Flight Procedures Cover Page	Task Action: FLIGHT CHECK	Task Type: Graphical DP	Estimated Chart Date: 11/05/2020	APWS Task ID: 6EEF29607BC94F55B88287C77E6457C9	APWS Project ID: 1BCE6AEA2A3D4E2F9B37C0D48EF797E7
Procedure: COLD BAY (OBSTACLE) (RNAV) TWO KING COVE AK PAVC		Enroute: YES	Specialist: Sweeting, Dexter		Agreement Number:
Airport ID: PAVC	Airport Name: KING COVE		Airport City: KING COVE		State: AK
Facility ID:	Facility Type:	Flight Inspection Remark Type: New FC Slot			
<p>Procedure Comments: PAVC MAG VAR UPDATE: OLD 14E - NEW 10E. PAVC RWY UPDATE: OLD R07/25 - NEW R08/26. CONTACT: DONALD LANIER 405-954-8242</p> <p>10/6/20: THIS IS A CORRECTED COPY OF THE FORM APPROVED ON 9/15/20. UPDATED PAGE NUMBERS.</p> <p>11/10/20: THIS IS A CORRECTED COPY OF THE FORM APPROVED ON 9/15/20. CHANGED 15C REMARKS FROM "CG 416 FT PER NM TO 2600" TO "CG 420 FT PER NM TO 2600"</p>

COLD BAY TWO DEPARTURE (OBSTACLE) (RNAV)

KING COVE (KVC)((PAVC)
AL-9292 (FAA) KING COVE, ALASKA

COLD BAY ONE DEPARTURE (OBSTACLE) (RNAV)

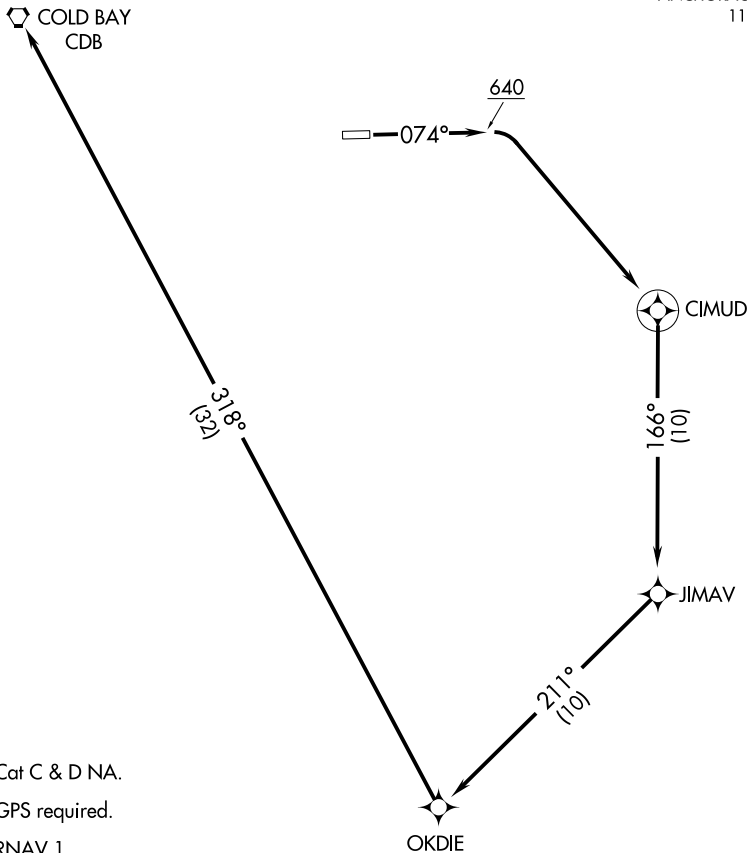
OLD

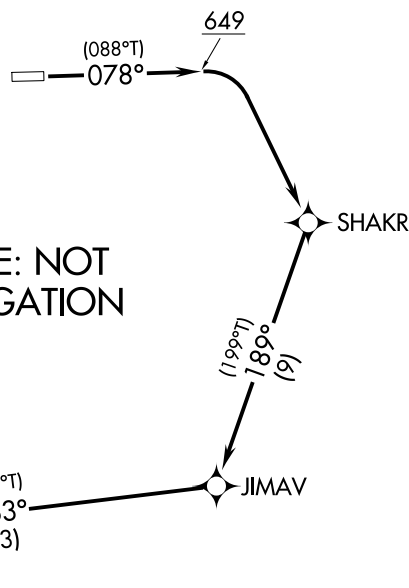
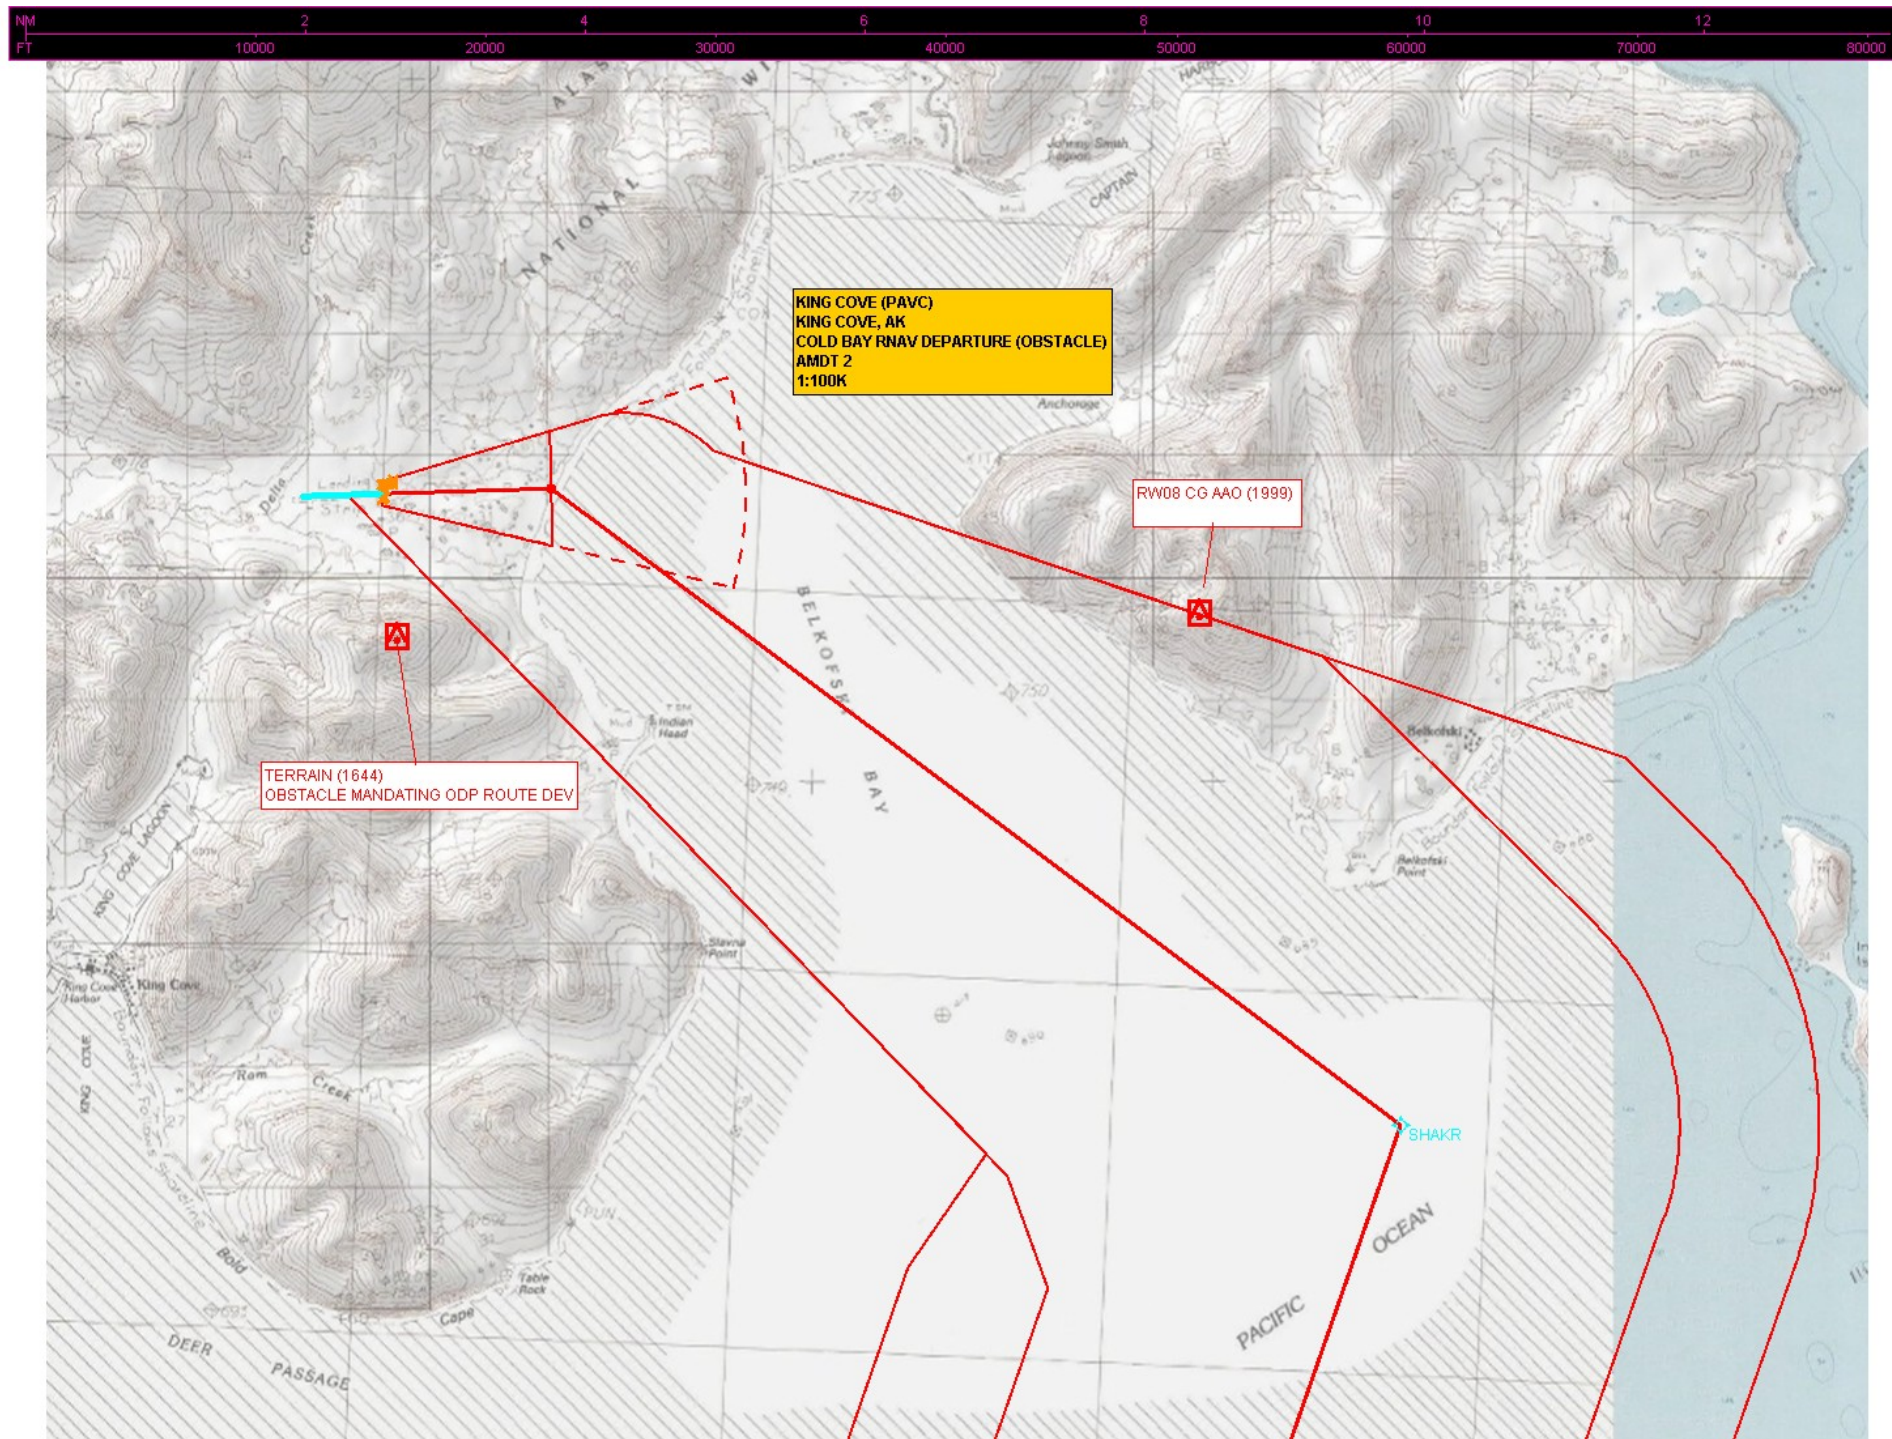
Cold Bay Departure (OBSTACLE)(RNAV) - WP CIMUD replaced by WP FITUX, WP OKDIE replaced by WP KOPEC

R07: Climb gradient of 464' per NM required to 3000'.

Rwy 8: Standard with a minimum climb of 420' per NM to 2600.
Rwy 26: NA-obstacles.

TAKEOFF RUNWAY 8: Climb on heading 078° to 649, then climbing right turn to 4000 direct SHAKR, then on track 189° to JIMAV, then on track 253° to KOPEC then on track 328° to CDB VORTAC.
